# Access Compliance Report

### (Curb Ramps)

Intersection ID: 49131	Main Street: EWERT_CUT_LN	Cross Street: WILTSHIRE_RIDGE_RD	Location:	N
ADA ID: 476C1487D60D	Ramp Type: Perp	Initial Pass/Fail: Fail	Overall Compliance: No	Severity Score: 12.5
Codes/Mitigation Info/Possible Solution		Field Measurements/Component Compliance

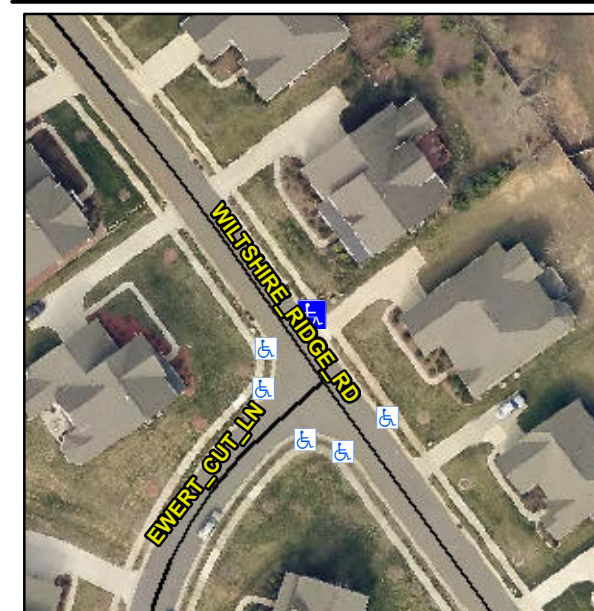
**Not Found, R304.5.3**

Compliance	Description	Data	Compliance	Description	Data
N/A	Ramp Length (in)	47.5	Yes	Ramp Slope (%)	5.9
Yes	Ramp Width (in)	49.0	No	Ramp XSlope (%)	5.7
N/A	Flare Type LT	N/A	N/A	Flare Type RT	N/A
N/A	Flare Slope LT (%)	N/A	N/A	Flare Slope RT (%)	N/A
N/A	Flare Traversable LT?	N/A	N/A	Flare Traversable RT?	N/A
N/A	Landing Length (in)	N/A	N/A	DWS Provided?	N/A
N/A	Landing Width (in)	N/A	N/A	DWS Contrast?	N/A
N/A	Landing Slope (%)	N/A	N/A	DWS Length (in)	N/A
N/A	Landing X Slope (%)	N/A	N/A	DWS Full Width?	N/A
N/A	Landing Curb? (Y/N)	N/A	N/A	DWS Offset (in)	N/A
N/A	Shared Landing?	N/A			
N/A	Gutter Ponding?	N/A	N/A	Gutter Slope (%)	N/A
N/A	Gutter Lip Ht (in)	N/A	N/A	Gutter X Slope (%)	N/A
N/A	Painted X Walk1?	No	N/A	Painted X Walk2?	N/A
	X Walk 1 Direction	To SW		X Walk 2 Direction	N/A
N/A	X Walk 1 Width (in)	N/A	N/A	X Walk 2 Width (in)	N/A
	X Walk 1 Slope (%)	5.3		X Walk 2 Slope (%)	N/A
	X Walk 1 X Slope (%)	7.8		X Walk 2 X Slope (%)	N/A

**Remove & Replace Entire Ramp.**
